MAJOR PROJECT ASSESSMENT:

***Concept Plan (MP 10_0112) and
Project Application (MP 10_0113)***

***Mixed Use Development at 110-114 Herring
Road, Macquarie Park***

Director-General's
Environmental Assessment Report
Section 75I of the
Environmental Planning and Assessment Act 1979

Figure 9: Recommended Modifications

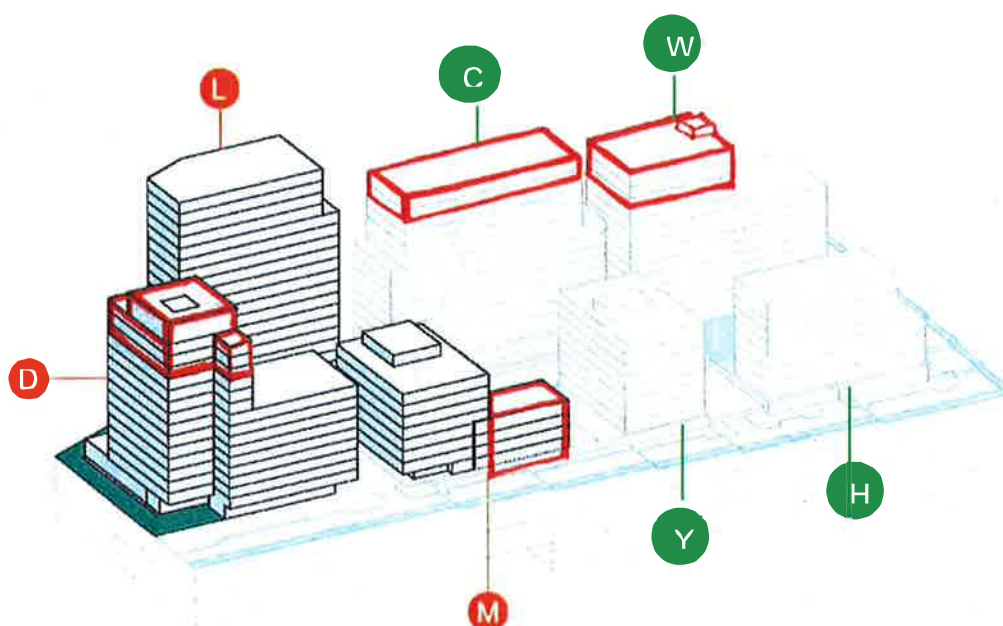
The Department supports increased heights and densities at this location and agrees with Council that modulation of the building envelopes is beneficial. However the Department recommends some modifications to envelope and building heights to improve contextual relationships and amenity. **Table 6** shows the Department's proposed modifications. A discussion on the modifications is provided below and illustrated in **Figure 9**.

Building W is located on the western corner of the site. This building is 9 storeys in height (plus plant) adjacent to the boundary, stepping up to 13 storeys. The building does not comply with Amendment No. 1 and it is the recommendation of this report that the 13 storey portion be reduced to 11 storeys. The reduction will ensure that the development transitions downward to be more consistent with likely future development on the adjoining site (being 8 storeys). In addition it will also transition up to emphasise the landmark building on the corner of Epping and Herring Road which is in accordance with Ryde LEP 2010's objectives to enable focal points at major intersections. For the reasons stated above it is considered that Epping Road is capable of accommodating some additional height.

Building	Proposed height	Department's recommendation
L	18-20 storeys	No change
C	15 storeys	13 storeys
W	9-13 storeys	9-11 storeys
H	5-8 storeys	No change
Y	8 storeys	No change
M	4-8 storeys	Delete 4 storey portion of the building to increase solar access to adjacent open space. This primarily relates to open space and is discussed in detail in Section 5.2.
D	15 storeys	12 storeys

Figure 11: Proposed Setbacks
(Source PPR February 2012)

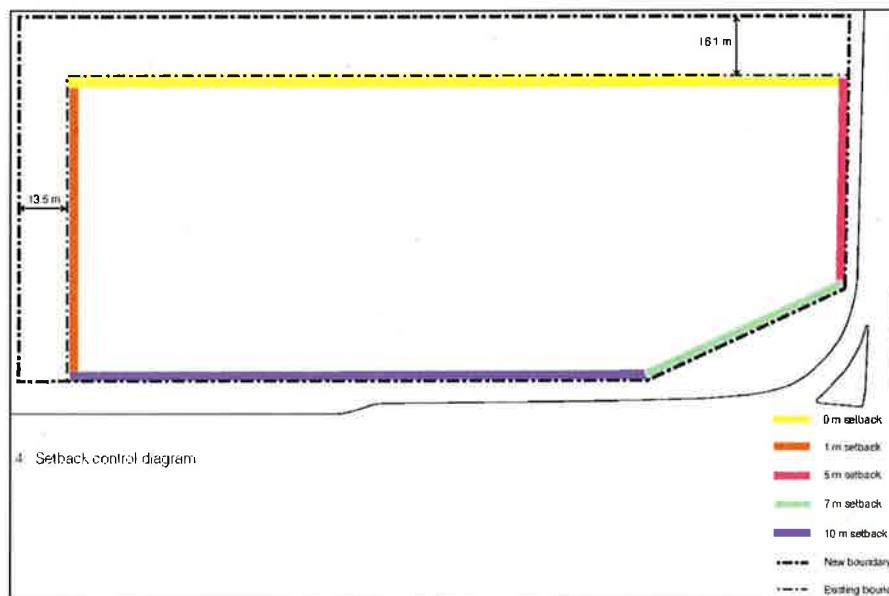
The development proposes setbacks of varying distances (**Figure 11**). The DCP requires a 10m setback to Epping and Herring Roads, whilst setbacks of 7m and 5m respectively are proposed. The proponent states that the proposed 7m setback at the intersection of Epping and Herring Road acknowledges the corner location and improves the definition of the corner and the landmark building. It also reduces conflict between the retail activities at ground level with the future RMS slip road. The proponent's views are supported.

Figure 19: Village Green and Children's Play Space (Source PPR February 2012)

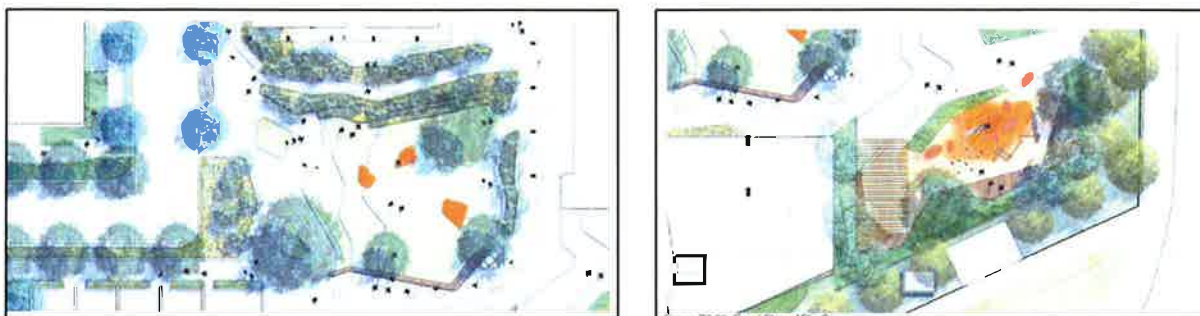
The Department has concerns regarding the children's play space being located in close proximity to busy roads. The garden is proposed to be surrounded by dense dwarf yellow gum trees to provide a natural edge to the space, however, the Department considers that a more restrictive boundary should be provided to ensure the safety of young children. Nonetheless, this space is considered beneficial to the development and the community.

Figure 20: Garden of Earthly Delights (Source PPR February 2012)

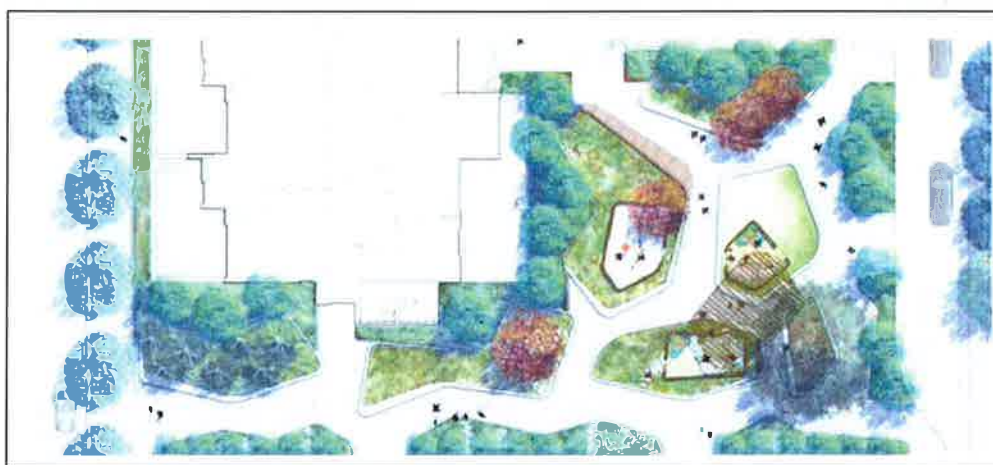
The central park is highly accessible, however, is significantly constrained by overshadowing. The proponent's shadow diagrams indicate that only a small portion, less than 50% at any time, will receive sunlight between 9 am and 12 noon in winter. There is no solar access to this area after midday. The central park is approximately 7 metres in width

In light of poor functionality and useability of the proposed open space, and lack of sufficient open space in Macquarie Park and to increase the overall amount of open space, it is recommended that the 4 storey portion of Building M along the north eastern boundary of the site be deleted (**Figure 9**). This will increase the open space by approximately 350m² and increase the central park and pool area from approximately 1,313m² to 1,665m². This will result in the loss of approximately 10 apartments (1.7% of the total proposed development). Removal of the building will also ensure this open space area will receive more than 2 hours of sunlight on the pool and soft landscaped areas.

Figure 22: DCP 2010 Macquarie University Precinct – Preferred Street Network (Source PPR February 2012)

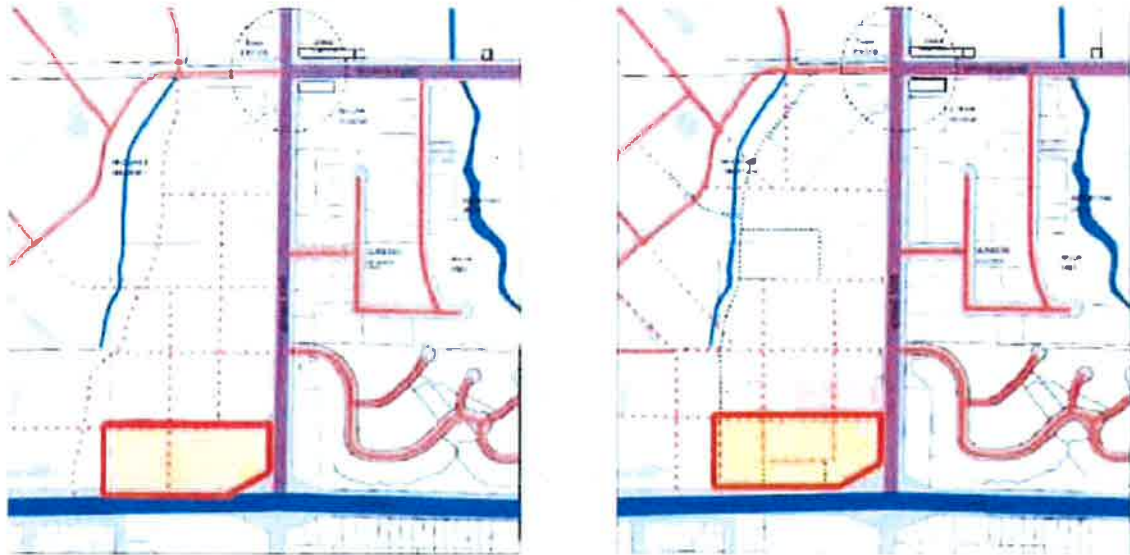
Following consultation with Council, the proposal departs from Council's DCP road network and seeks to provide two new local streets along the north eastern and north western boundaries of the site. These are to be dedicated as public roads to council. Only one half of the road will be constructed on the site's northwestern boundary and the other half will be completed when the adjacent site redevelops.

The proposed road network provides increased permeability and contributes to Council's fine grained road network. The revised road network is appropriate and allows the potential for Council's road network to be achieved in the future.
